NUMBER D2-14827

TITLE TECHNICAL FACILITY CRITERIA FOR THE MINUTEMAN LAUNCH
CONTROL FACILITIES, FRANCIS E. WARREN AFB, WYOMING (U)

MODEL NO. WS-133A CONTRACT NO. AF04(694)-107

- b. Document D2-14827 identifies the revised or additional requirements to site adapt and upgrade the Minuteman Launch Control Facilities for Francis E. Warren AFB in accordance with the latest Weapon System improvements. These requirements are identified by paragraph and figure notations corresponding to those in Document D2-13798 (Revision A).

D2-14827
FIG.5-6
PAGE
13

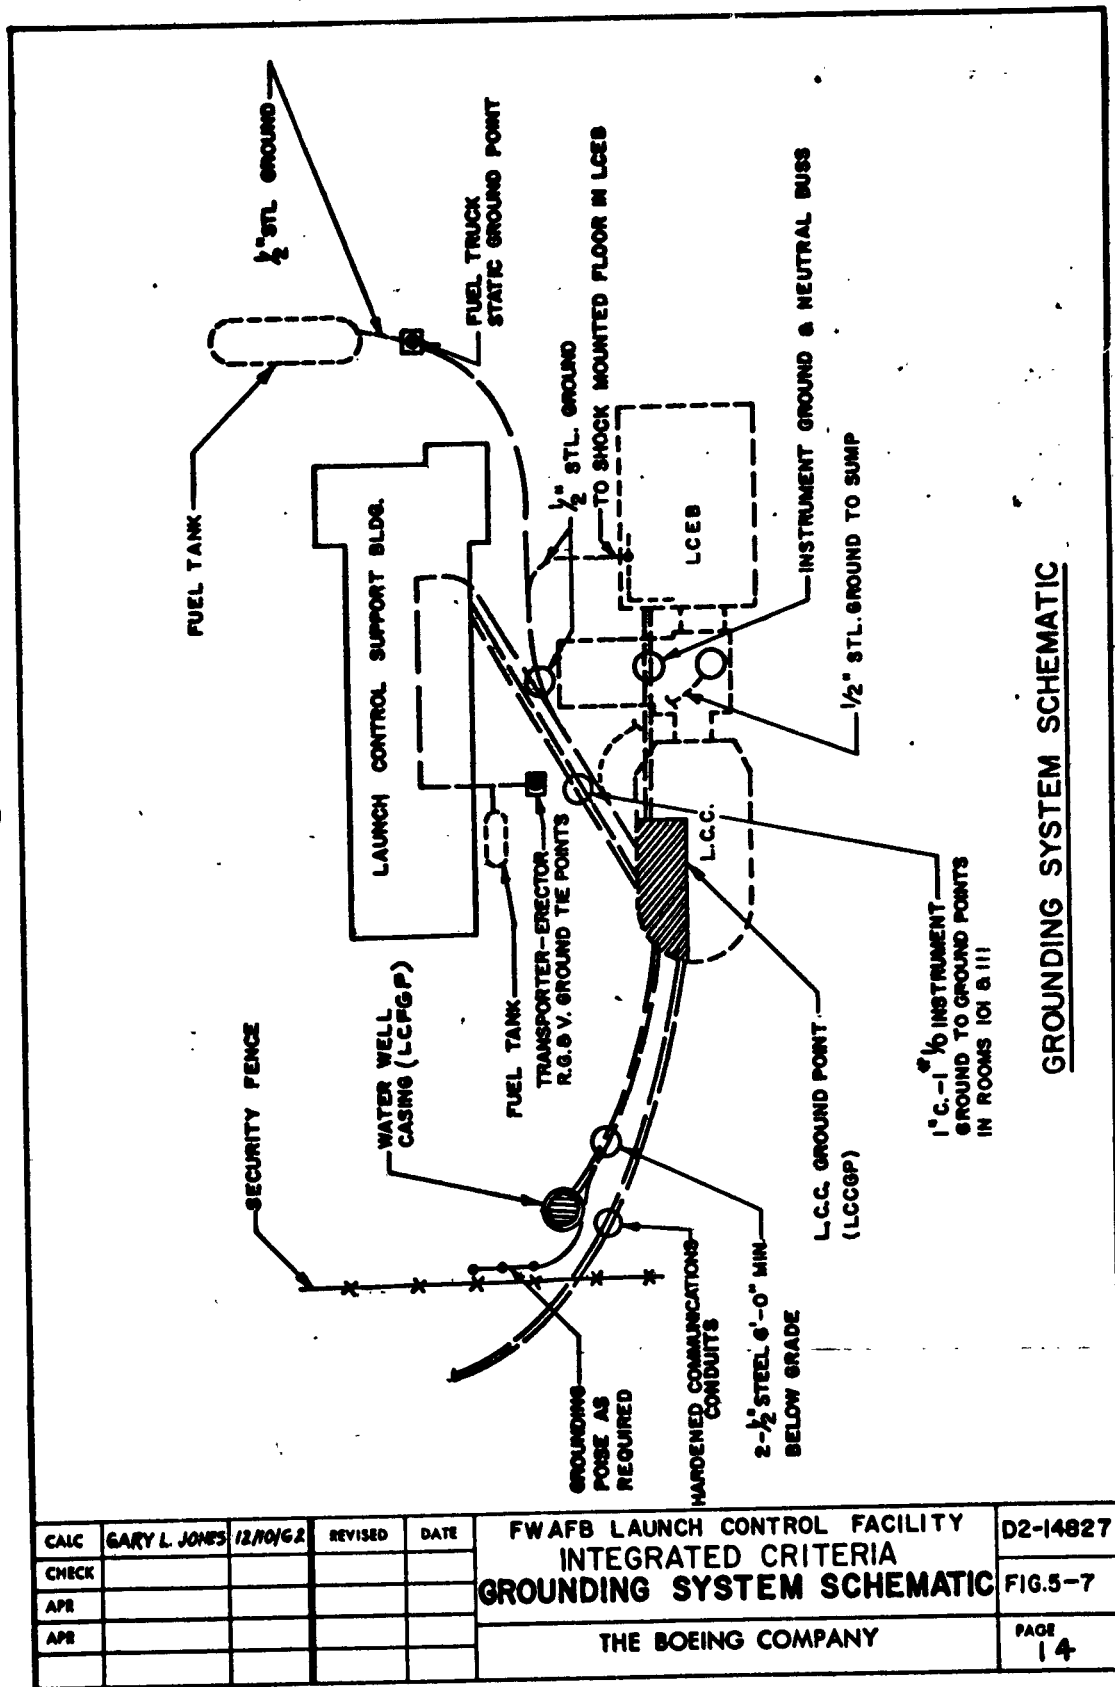
1. Figures 5-5, 5-6, 5-7, 5-8 and 5-8.1 revised per conduit changes.
2. Table 5-1 Equipment List LCF revised per LCEB equipment changes.

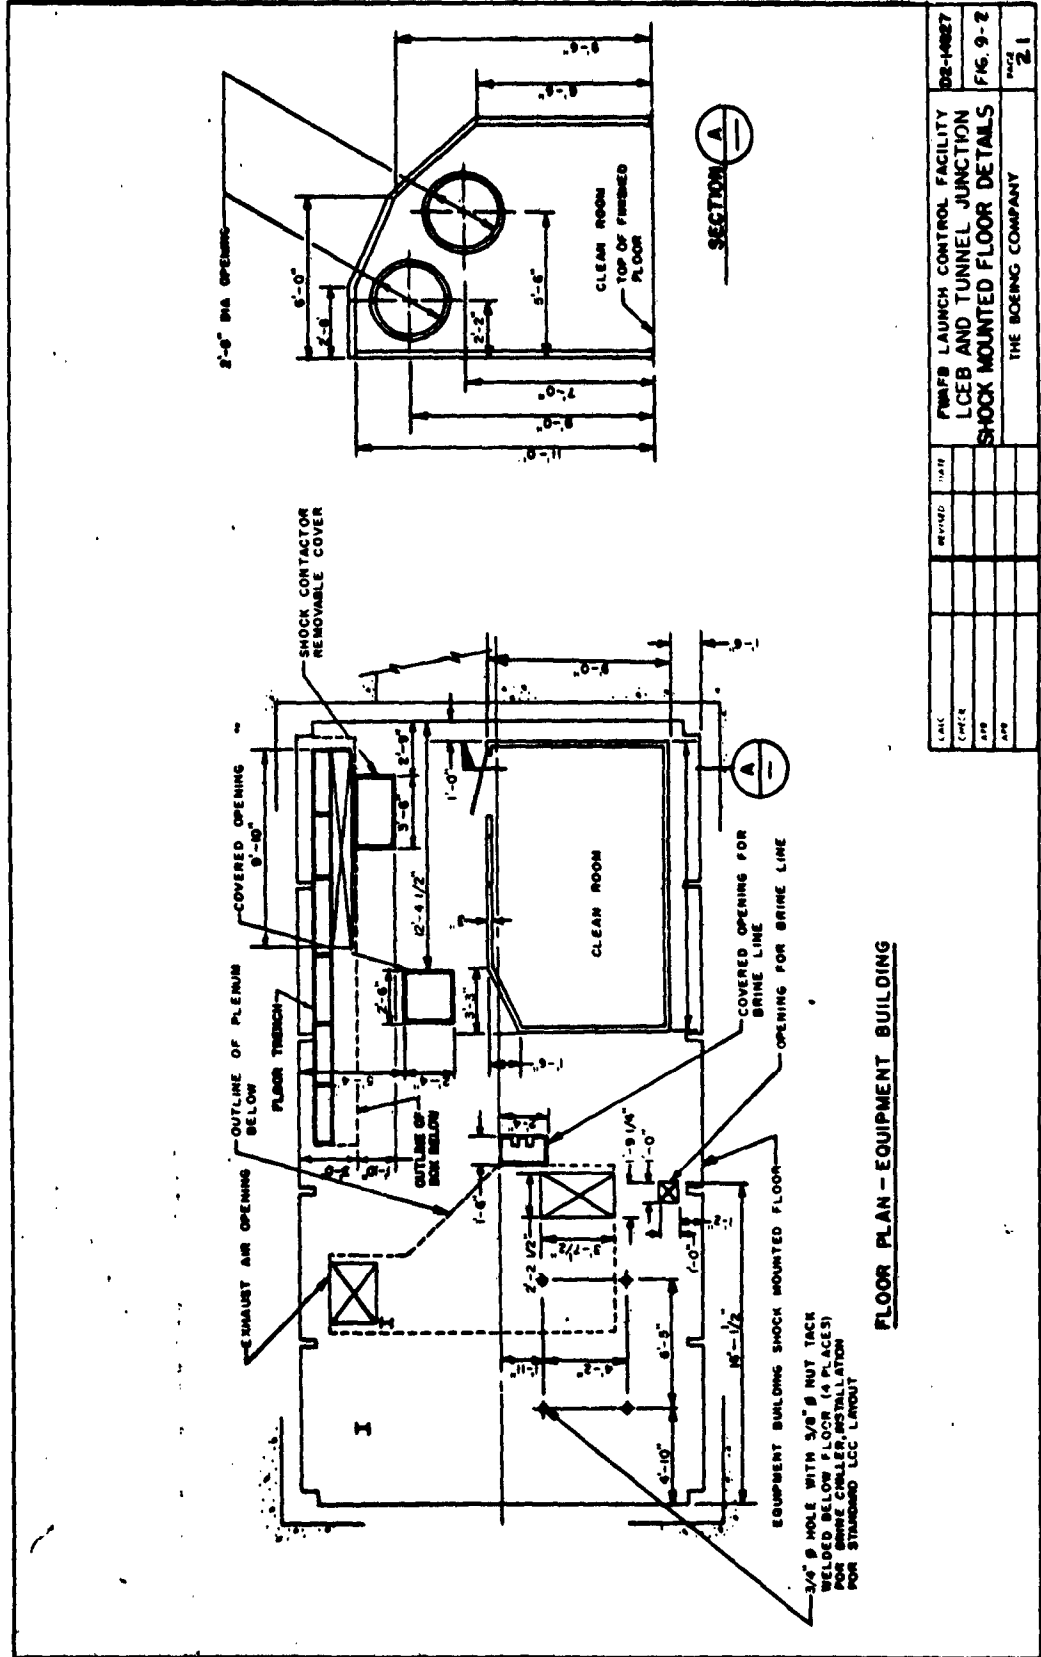
1. Figure 6-1.1 revised per dimension change.
2. Figure 6-3 revised per conduit changes.

DATE	REVISED	BY	THE BOEING COMPANY	DS-14827
1967				FIG. 9-2
1967				21

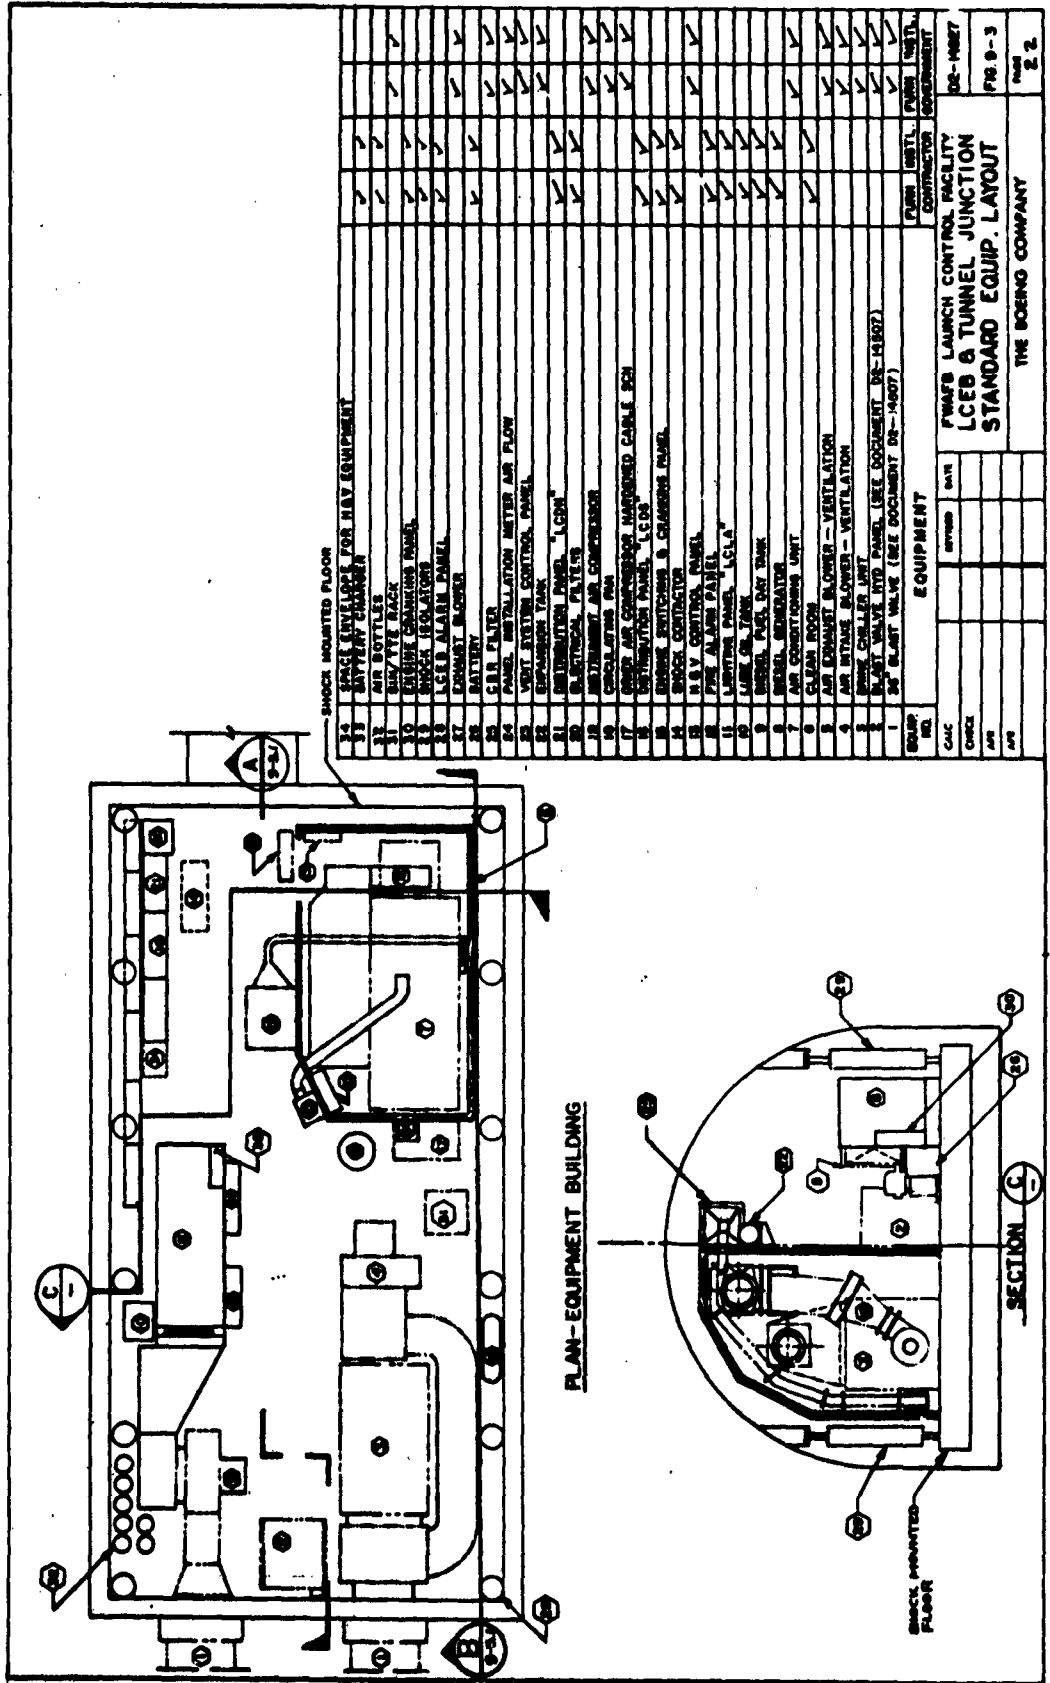
1. Figures 9-2, 9-3, 9-3.1, 9-3.2, 9-3.5, 9-3.6, 9-3.7, 9-4 and 9-7 revised per RPIE changes.
2. Figures 9-6 and 9-6.1 revised per blast valve changes.

LAUNCH CONTROL CENTER 24" BLAST VALVE REQUIREMENTS

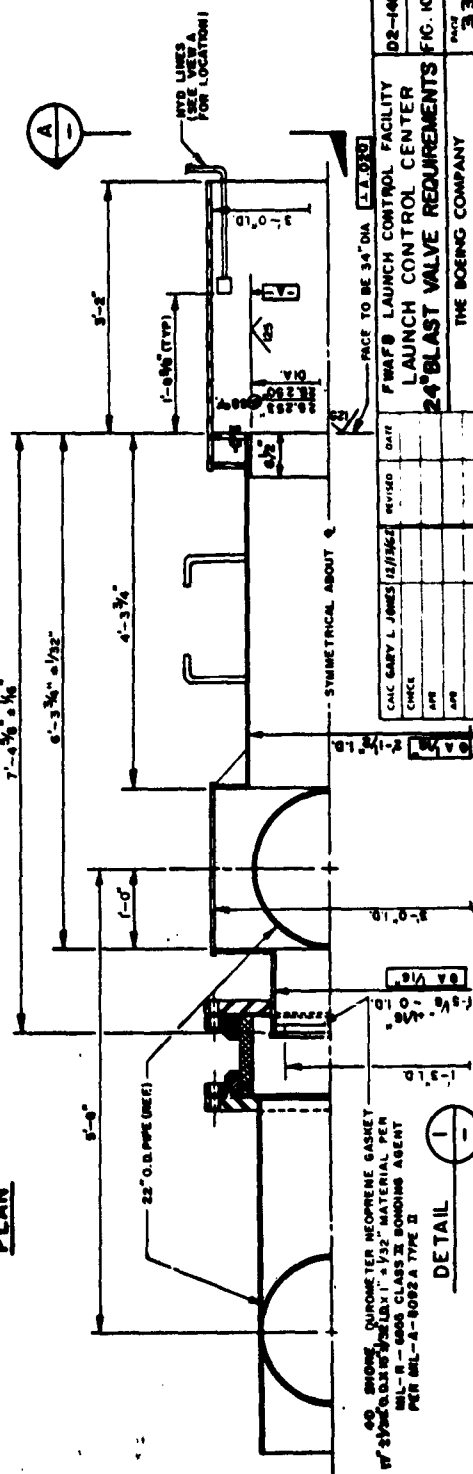
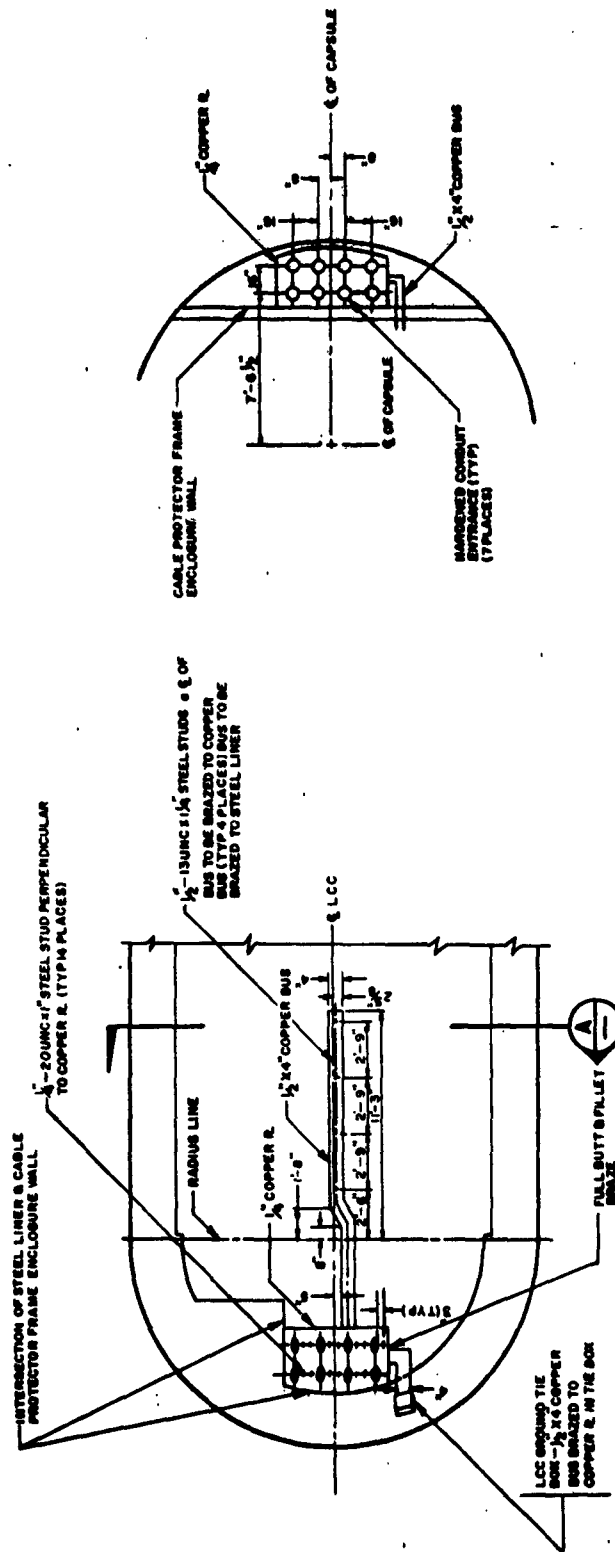
- 1. Figures 10-9 and 10-9.1 revised per blast valve changes.
- 2. Figure 10-10 revised to provide cable tray opening.
- 3. Figure 10-14.1 and 10-17 revised per conduit changes.
- 4. Figures 10-15 and 10-16.3 revised per cable tray changes.

CASE	DATE	REVISED	DATE	PHAF'S LAUNCH CONTROL FACILITY HF/UHF ANTENNA FACILITY CONDUIT-STUD-OUT POINTS	02-14-82
CHIEF					
APP					
APP					
THE BOEING COMPANY					02-14-82
					02-14-82
					02-14-82

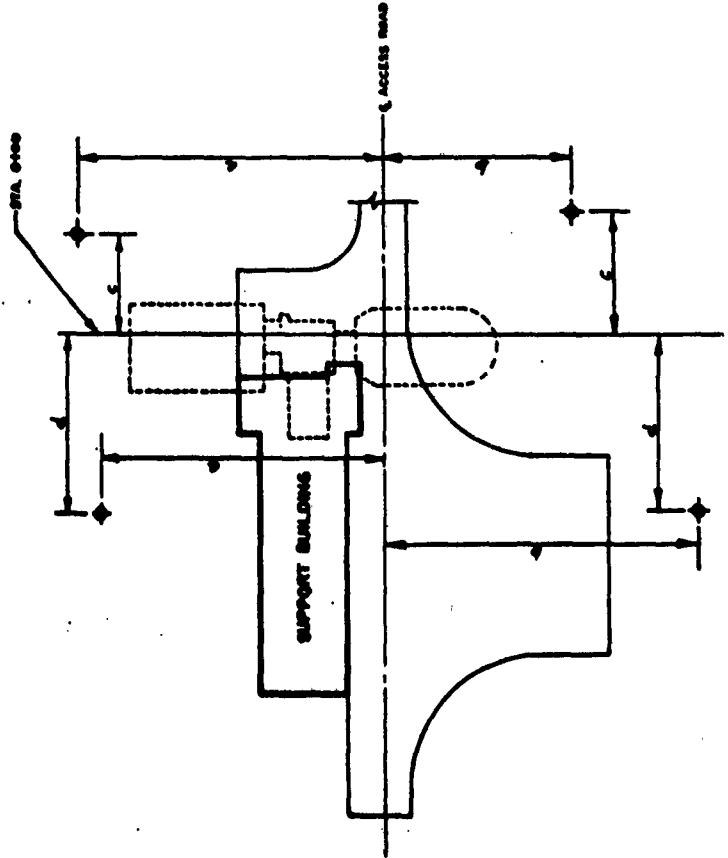
1. Figures 11-8, 11-9, and 11-9.1 revised per new siting requirements.
2. Figures 11-8.1, 11-8.2 added per new siting requirements.
3. Figure 11-9.2 deleted per new siting requirements.
4. Figure 11-1 revised per conduit changes.
